COUNCIL ASSESSMENT REPORT SYDNEY CENTRAL CITY PLANNING PANEL

| PANEL REFERENCE & DA NUMBER | PPSSCC-433 - DA 1356/2023/JP |
| PROPOSAL | Mixed Use Commercial Development Including Office premises, Food and Drink Premises and Function Hall |
| ADDRESS | 12 Norbrik Drive Bella Vista |

Figure 3: Encroachment on View Cone 2 (highlighted yellow)

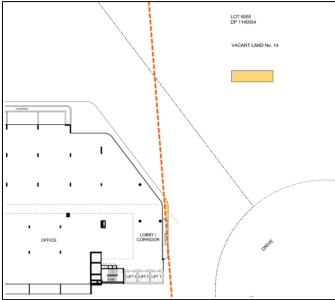
The awning and roof encroachment on View Cone 2 is depicted below:

The awning and roof structure encroachment of up to 1.5m is not visible when looking northeast along view cone 2 and 5. As such, the minor encroachment generates negligible impact on heritage views. The encroachment will not be visible to pedestrians and road users along the Norbrik Drive corridor.

Figure 5: Encroachment on View Cone 5 (highlighted yellow)

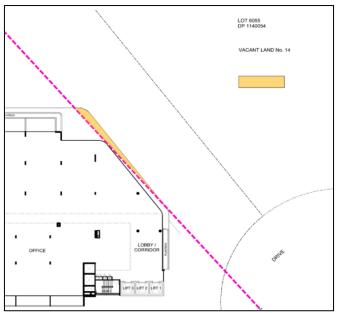
The proposal includes the following encroachments within the view cones:

Figure 8: Appendix A in DCP 2012 - Part D Section 22 Circa Commercial Precinct

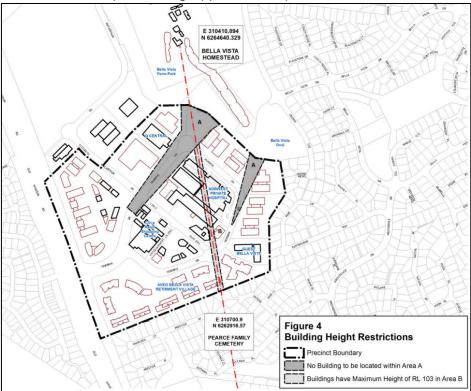
The proposal includes a gazebo, fencing and signage which are structures located within the hatched area marked 'A'. An assessment of these structures with respect to impact to preserving the heritage view corridor is detailed below.

In response to Council's previous heritage comments, the signage wall proposed fronting Norbrik Drive has been relocated outside of the significant view cone. No objection is raised to the amended location of the signage wall as it will result in an improved heritage outcome.

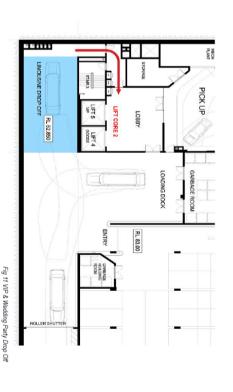
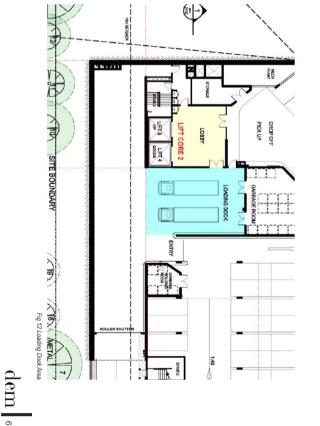
- The volume of arrivals being dropped off at the roundabout before and after events
- The capacity for turning circles for larger passenger vehicles such as stretch limousines. The Panel recommends the entry to the site be thoroughly reviewed. The Panel believes with some design

- detail in Item 24 26 on the Landscape Design changes these concerns could be resolved. The garden as previously noted is extremely important and the reference to the Italianate Garden could be extended into the arrival sequence. This is addressed in greater

- The arrival experience for all visitors is explained in detail in the Operational Management Plan submitted with the DA lodgment and reflects how the owner /operator is intending to manage the Function Centre.

- WEDDING PARTY & VIP ARRIVALS:
- of the driveway A designated undercover wedding party / VIP drop off and pick up area will be located adjacent to loading dock area at the end

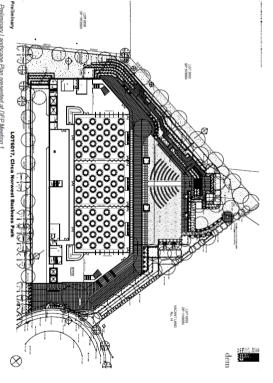
- team 26. The Panel does not support the quantum of hardscape currently dominating the front setback zone. The Panel was informed at the meeting that the redesign of this precinct is already being addressed by the design
- enhance the arrival sequence. forecourt paving could be extended across the driveway to improve pedestrian priority and safety, and further New Comment: The Panel notes and supports the additional landscaping provided at the street interface. The

New Comment: This comment remains relevant.

- The landscape plan included in the DA submission and presented at DEP Meeting 2 incorporated:
- 1. A substantial increase in the area of native and indigenous planting adjacent to the north-west boundary replacing a proposed area of turf.

- 2. Mass planting along the northern boundary replacing turf.
- 3. Increased planting in the north-east corner of the site due to realignment of the main ceremonial axis
